1 ADDENDUM #3

Project Title: Holland College Summerside Waterfront - GreenBuild Trade Expansion
98 Water Street, Summerside PE

Project Title: Holland College Summerside Waterfront - GreenBuild Trade Expansion
98 Water Street, Summerside PE

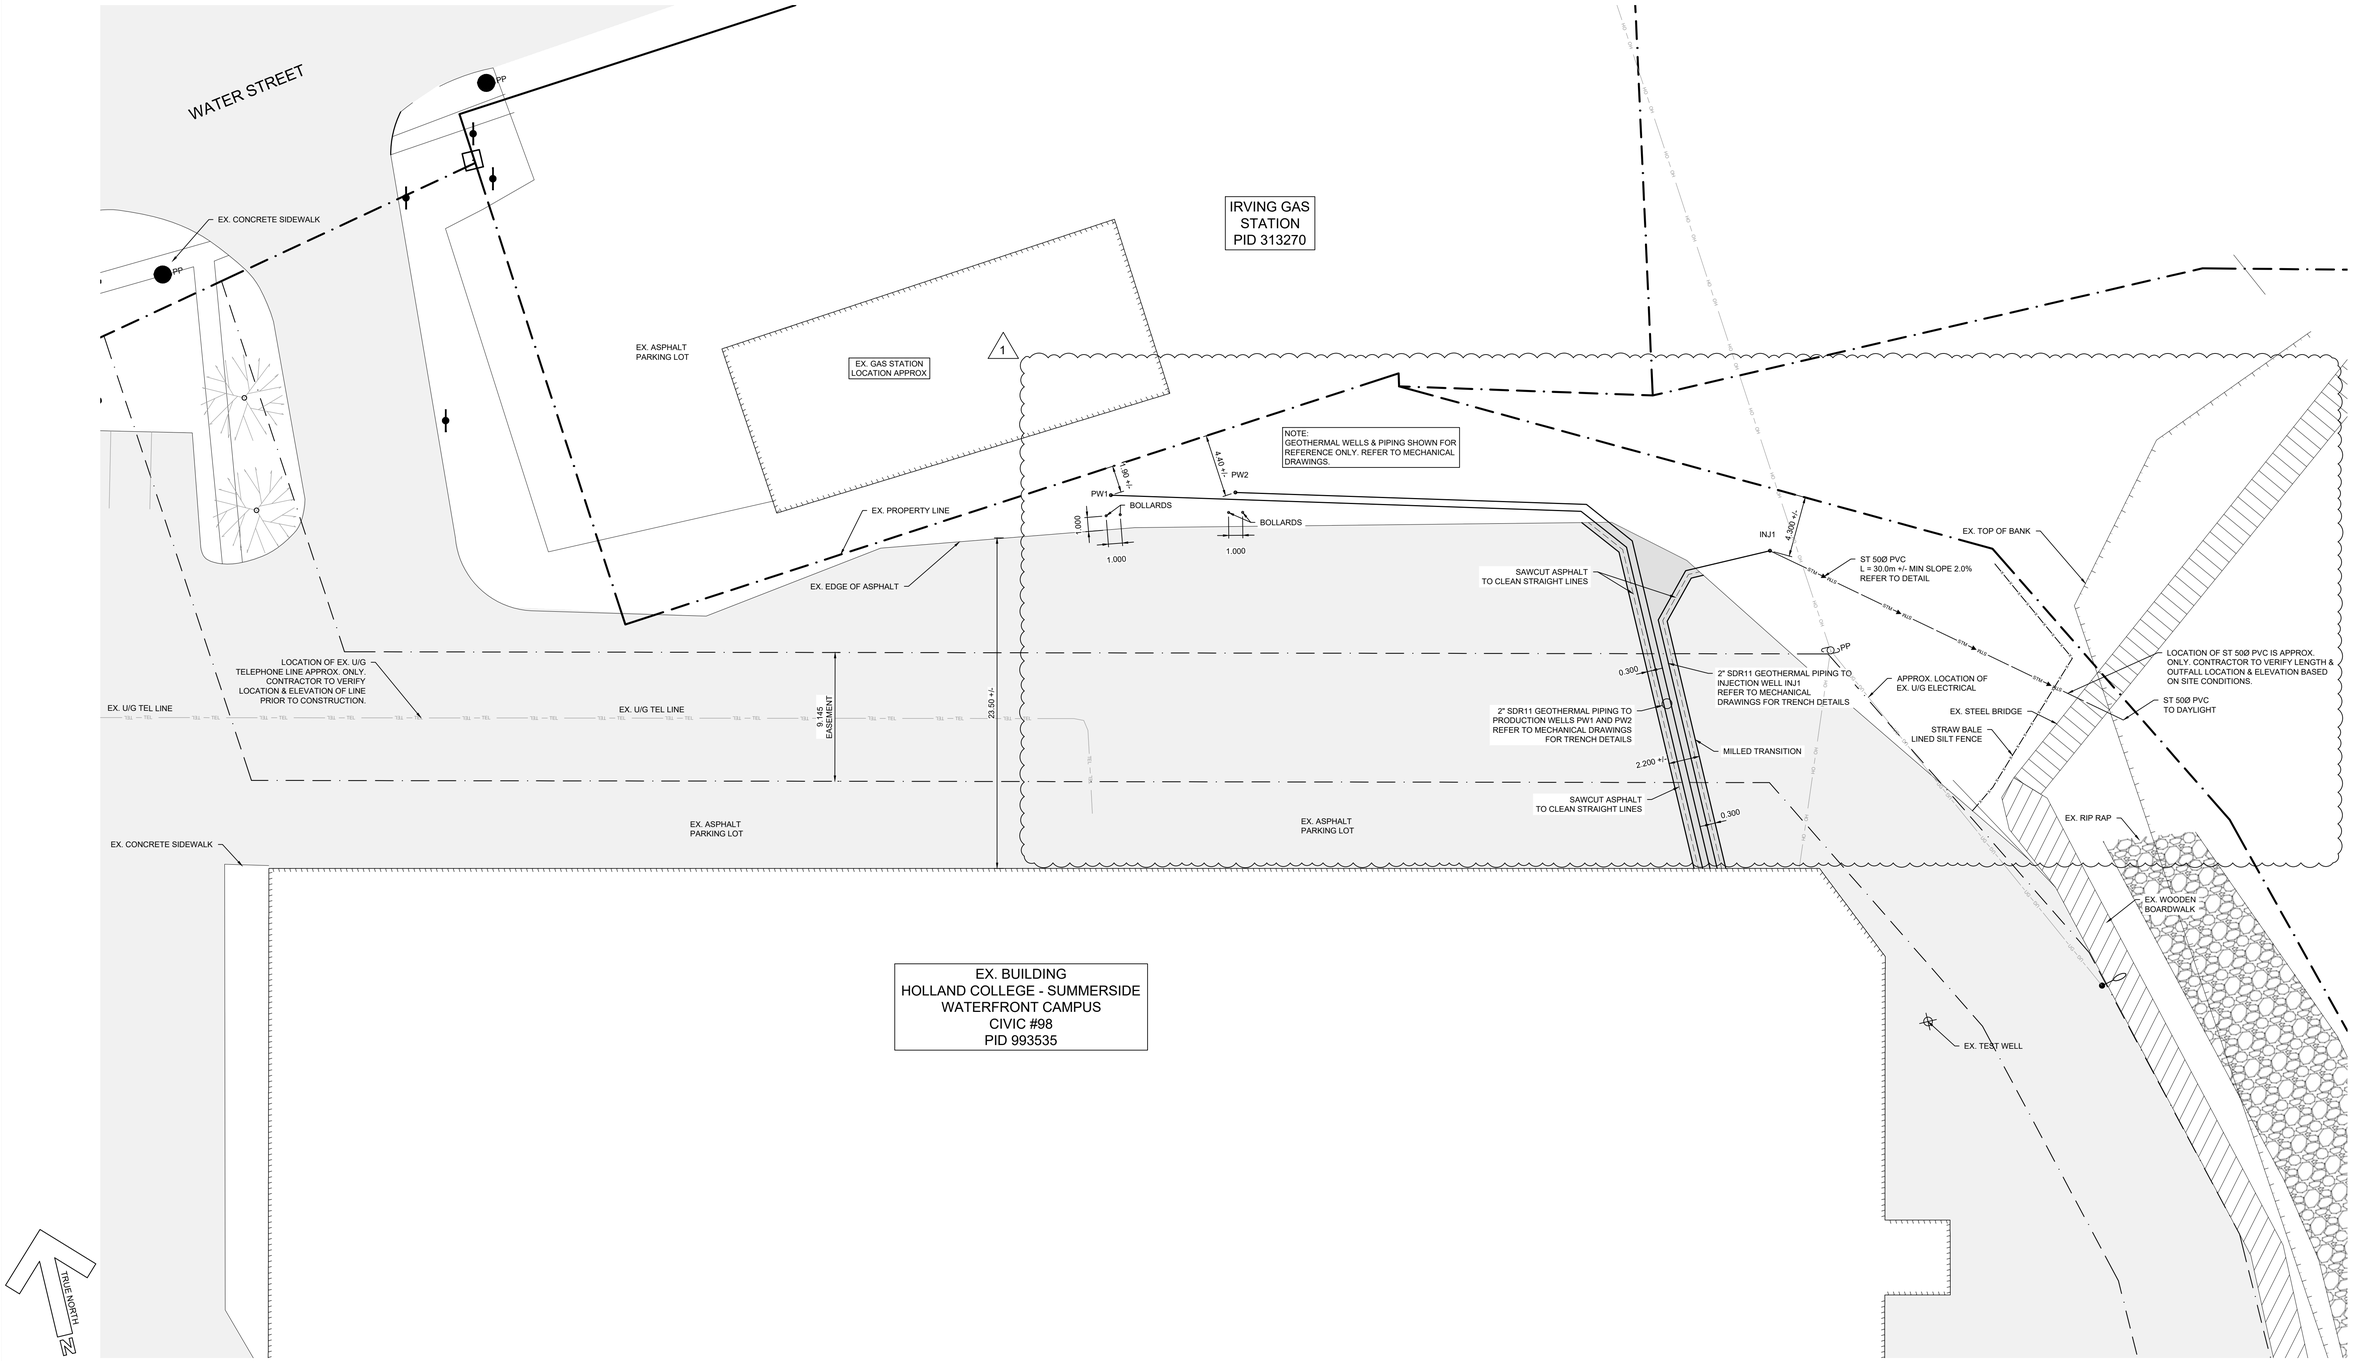
.18 Reference Drawing E001 - Legend, Full Building & Site Plan, Existing Freezer Enlargement & Trench Detail:
- .1 Reference Detail 1/E001:
  - .1 Two (2) existing switches located on the south wall of Main Hall 333 adjacent to west wall to be removed. Existing branch circuit wiring to be traced out, disconnected, and capped and coiled in the accessible ceiling space for future reconnection to new light switches. Reference ASK005 for additional information on new main entrance.

- .2 Two (2) switches to be added to the to the west wall adjacent to Door 333.2 and connected to existing branch circuit wiring capped and coiled in the accessible ceiling space. Existing branch circuit wiring to be spliced and extended if required. Reference ASK005 for additional information on new main entrance.

- .3 One (1) emergency lighting unit located on the south wall of Main Hall 333 adjacent to west wall to be traced out, disconnected, and removed. Existing branch circuit wiring to be traced out, disconnected, and capped and coiled in the accessible ceiling space for future reconnection to new emergency lighting unit.

- .4 One (1) emergency lighting unit to be added to the south wall of Main Hall 333 adjacent to wooden feature panel. Emergency lighting unit to be connected to existing branch circuit capped and coiled in the accessible ceiling space. Existing branch circuit wiring to be spliced and extended if required. Reference ASK005 for additional information on new main entrance.

- .5 One (1) communication device located on the south wall of Main Hall 333 adjacent to west wall to be traced out, disconnected, and relocated further east along the south wall adjacent to wooden feature panel. Existing mounting height is to be maintained. Associated communications cabling to

be traced out, disconnected, and capped and coiled in the accessible ceiling space for future reconnection to relocated device. Reference ASK005 for additional information on new main entrance.

.6 One (1) track light furthest west in existing track lighting located on the south side of Main Hall 333 above wooden feature panel to be traced out, disconnected, and removed. Associated track to be cut back to accommodate new wall and resuspended from exposed ceiling space. Reference ASK005 for additional information on new main entrance.

.7 One (1) track light furthest west in existing track lighting located on the north side of Main Hall 333 above wooden feature panel to be traced out, disconnected, and removed. Associated track to be cut back to accommodate new wall and resuspended from exposed ceiling space. Reference ASK005 for additional information on new main entrance.

1 ASK005 MAIN LEVEL - MAIN ENTRANCE
1/8" = 1'-0"

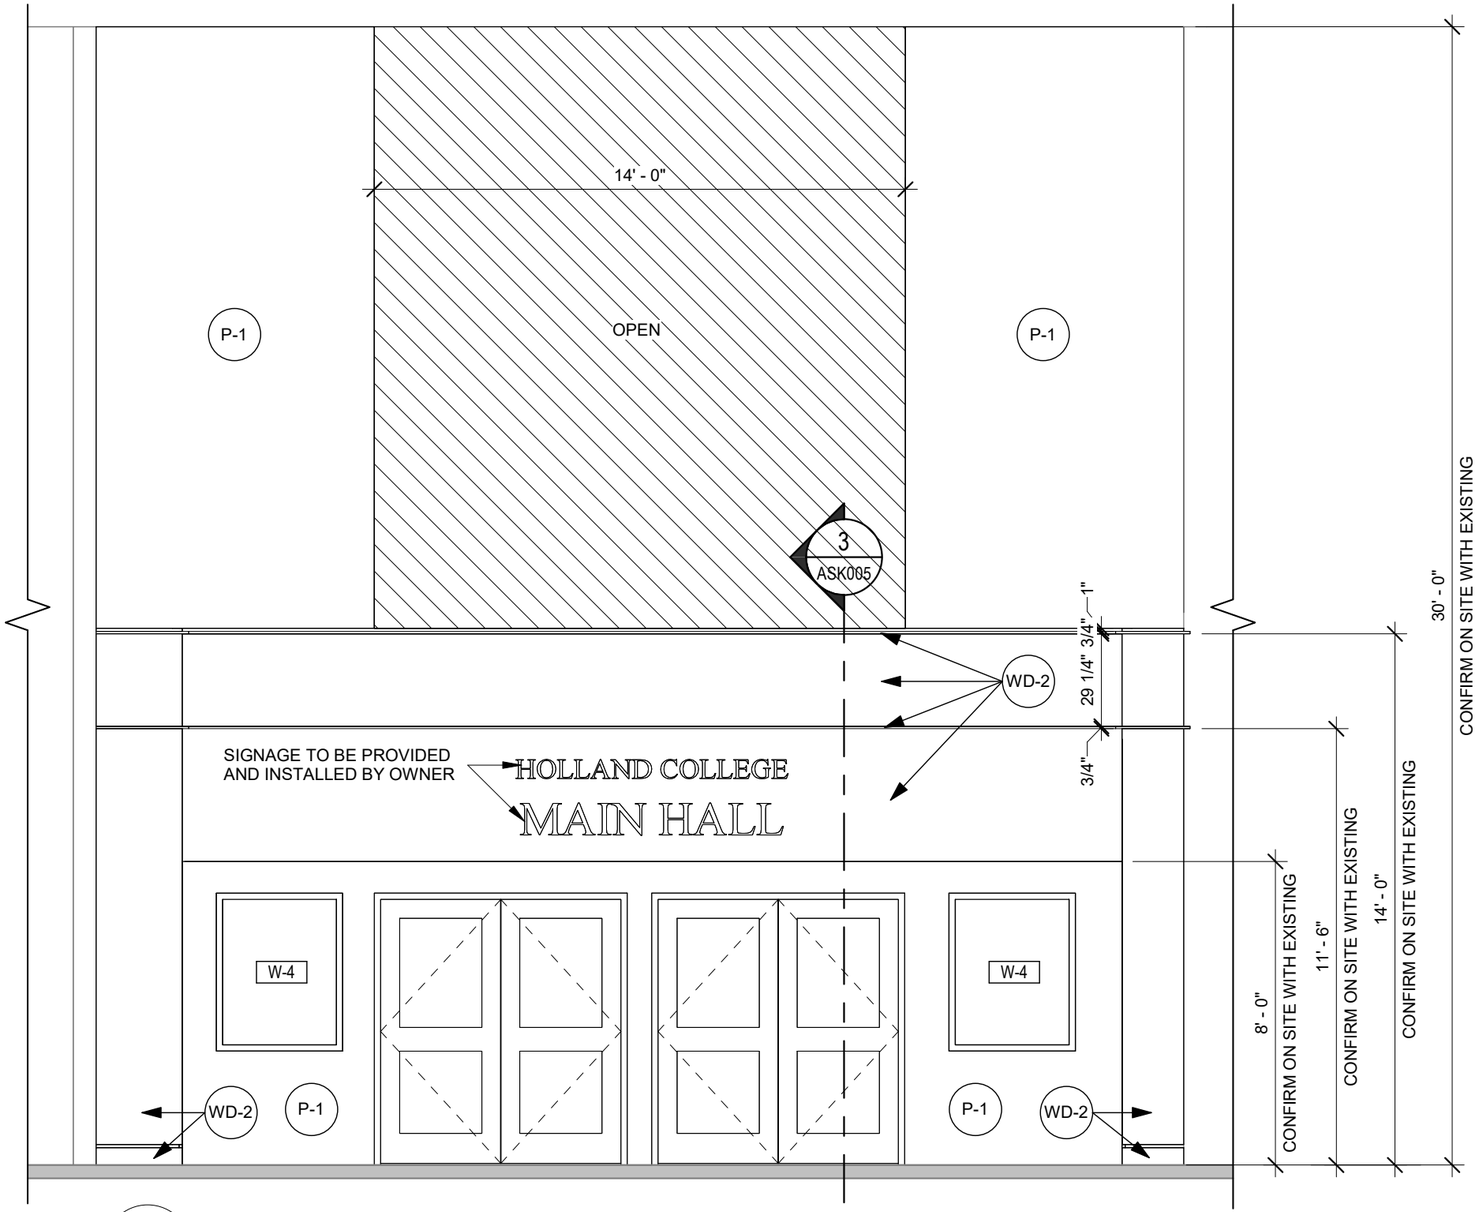
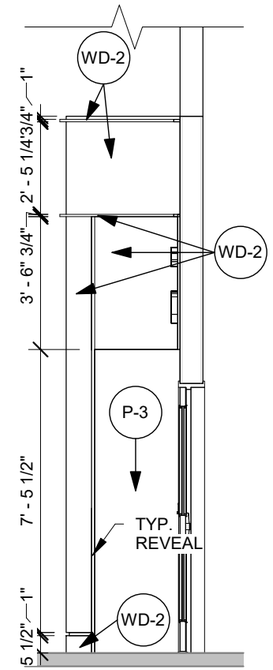
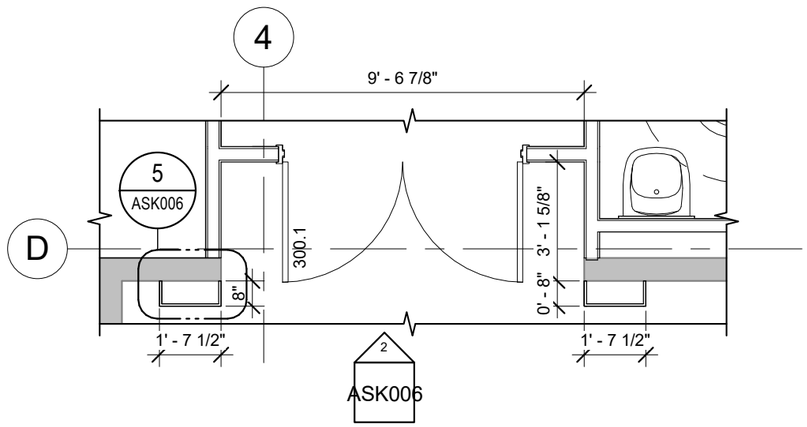
.3 Reference Drawing A100 - Floor Plans:
- .1 Reference detail 3/A100 MAIN LEVEL – HALL ENTRANCE:
  - .1 Delete and replace with ASK005 and ASK006 dated November 16, 2026.
- .2 Reference Metal Stud Wall Type Schedule:
  - .1 Reference Tag M1:
    Wall type "M1" height to be underside of existing steel deck including MECH.ROOM 331 wall, except in the areas listed below, where the height shall be 12'-0":
    - .1 Classrooms 301 and 306 walls
    - .2 Common Area 300 walls
    - .3 Offices 302 and 303 walls
    - .4 BF Washrooms 304 and 305 walls
    - .5 Storage 307 walls
  - .2 Reference Tag M2:
    All fire rated walls shall extend to the underside of the existing steel deck. Delete 3 5/8" / 92mm metal stud framing and replace with 6" / 152mm metal stud framing.

.5 Reference Drawing A500 – Enlarged Washroom Plan & Interior Elevations:
- .1 Delete detail 2/A500 and detail 3/A500 and replace with ASK005 and ASK006 dated November 16, 2026.

REVISED MECH ROOM 331 – HYDRONIC SUPPLY & RETURN PLAN

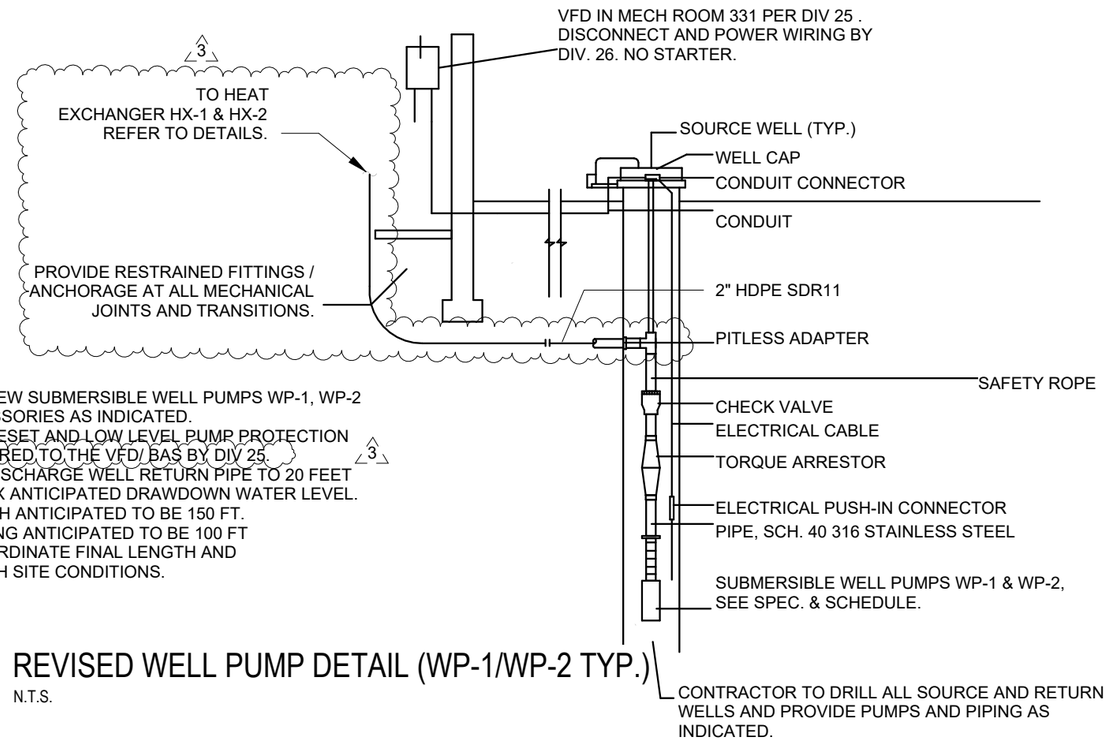
.11 Drawing M200 – Heating Hydronic Supply & Return:
- .1 Mech Room 331: Refer to Detail 1/MSK001 for revised layout, VFD location and UH-1.
- .2 Add heating bypass line at location shown on Detail 2/MSK002.

REVISED WELL PUMP DETAIL (WP-1/WP-2 TYP.)

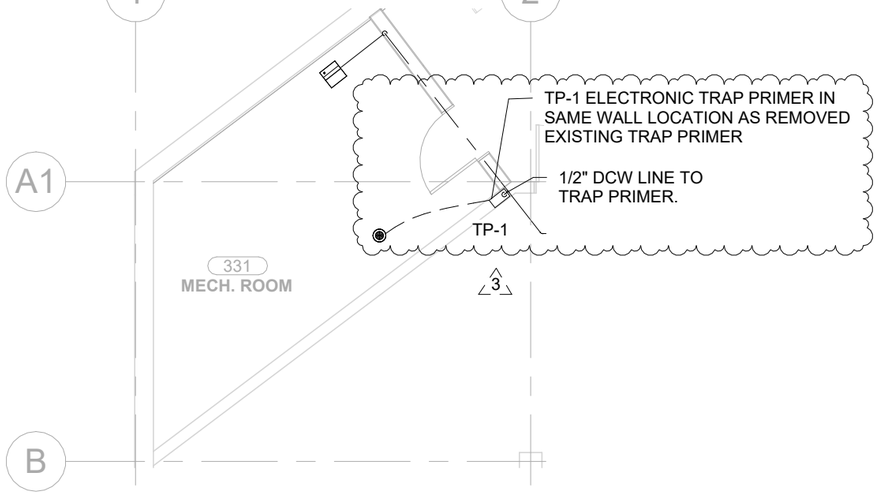
.10 Drawing M103 – Plumbing Details & Schedules:
- .1 Replace Detail 5, Well Pump Detail, with Detail 2/MSK001.
- .2 Plumbing Fixture Schedule: Add TP-1 per Trap Primer Schedule on MSK007.

PARTIAL PLUMBING DOMESTIC WATER MAIN FLOOR PLAN– NEW TRAP PRIMER LOCATION

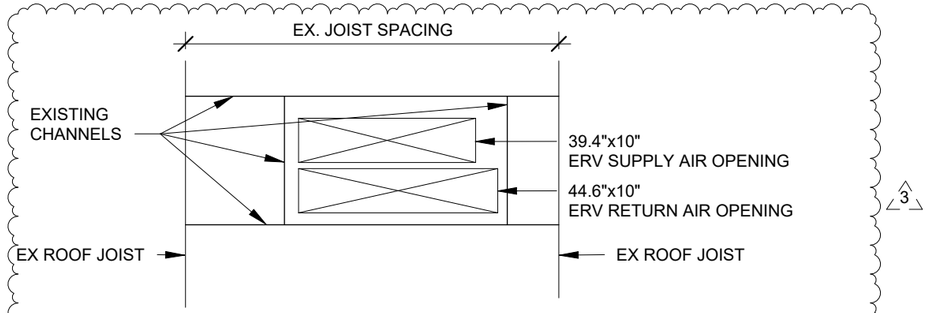
.6 Reference Drawing M010 – Plumbing Demolition:
- .1 Mech Room 331: Add removal of existing in-wall trap primer serving existing floor drain per Detail 3/MSK001.
- .2 Mech Room 331: Revise slab notes to read:
  "Sawcut and remove existing slab as required for new FFD-2." Delete "Tie FD-1 drain to existing floor drain sanitary piping."

.9 Drawing M101 – Plumbing Domestic Water:
- .1 Mech Room 331: Provide new electronic trap primer TP-1 at location of existing trap primer removed, per Detail 3/MSK001 and Trap Primer Schedule on MSK007.

1 MSK002 — REVISED ERV ROOF OPENING DETAIL
N.T.S.

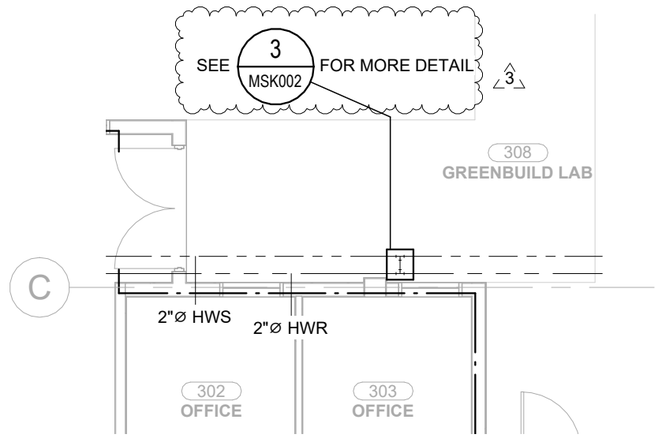
.15 Reference Drawing M204 – Heating Schedules:
- .1 Replace Detail 4, ERV Roof Opening, with Detail 1/MSK002.
- .2 Add Detail 5/MSK002, Duct Drop to Sidewall Supply/Return Serving S&R Corridor.
- .3 Grille & Diffuser Schedule, S-1: Revise note to read:
  "Self-actuating thermostatic diffuser c/w integral wax-piston element that automatically adjusts blades based on supply air temperature. Integrated air equalizer. Install suspended from structure at 16'-0" AFF."
- .4 Grille & Diffuser Schedule, S-2: Replace with S-2 per Grille & Diffuser Schedule on MSK008.
- .5 Replace ERV Schedule with Revised ERV Schedule on MSK007.

.17 Drawing M302 – Ventilation Details & Schedules:
- .1 Replace Detail 4, ERV Roof Opening, with Detail 1/MSK002.
- .2 Add Detail 5/MSK002, Duct Drop to Sidewall Supply/Return Serving S&R Corridor.
- .3 Grille & Diffuser Schedule, S-1: Revise note to read:
  "Self-actuating thermostatic diffuser c/w integral wax-piston element that automatically adjusts blades based on supply air temperature. Integrated air equalizer. Install suspended from structure at 16'-0" AFF."
- .4 Grille & Diffuser Schedule, S-2: Replace with S-2 per Grille & Diffuser Schedule on MSK008.
- .5 Replace ERV Schedule with Revised ERV Schedule on MSK007.

3 MSK002 — HEATING BYPASS LINE
N.T.S.

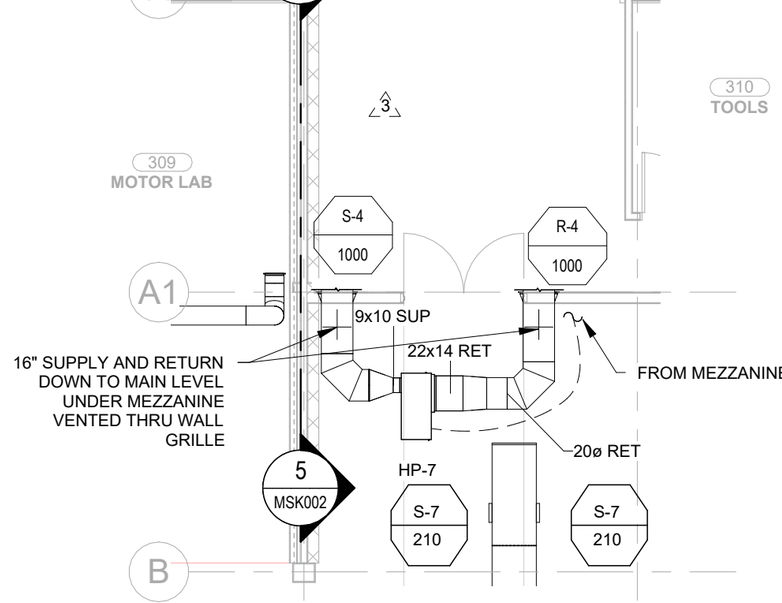
.14 Drawing M203 – Heating Details:
- .1 Add Detail 3/MSK002, Heating Bypass Line.
- .2 Reference Detail 6: Revise filter inlet and outlet piping from 3"Ø to 2"Ø.
- .3 Add Detail 6/MSK002, Pot Feeder Detail.

4 MSK002 — PARTIAL MAIN FLOOR PLAN – S&R CORRIDOR DUCT DROP
1/8" = 1'-0"

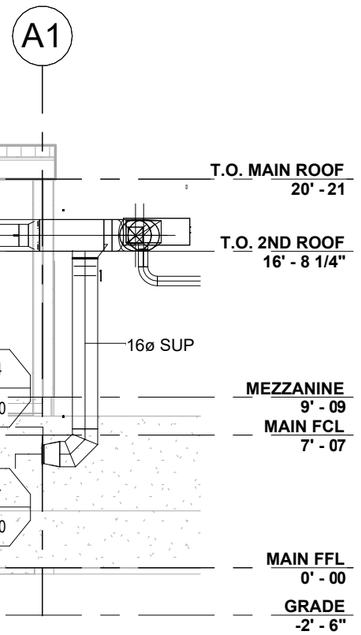
.16 Drawing M300 – Ventilation Supply & Return:
- .1 Add section cuts at S&R corridor duct drop per Detail 4/MSK002.
- .2 General Ventilation Note 11: Revise to read:
  "Insulate ductwork (concealed and exposed) as scheduled in Section 23 07 13."
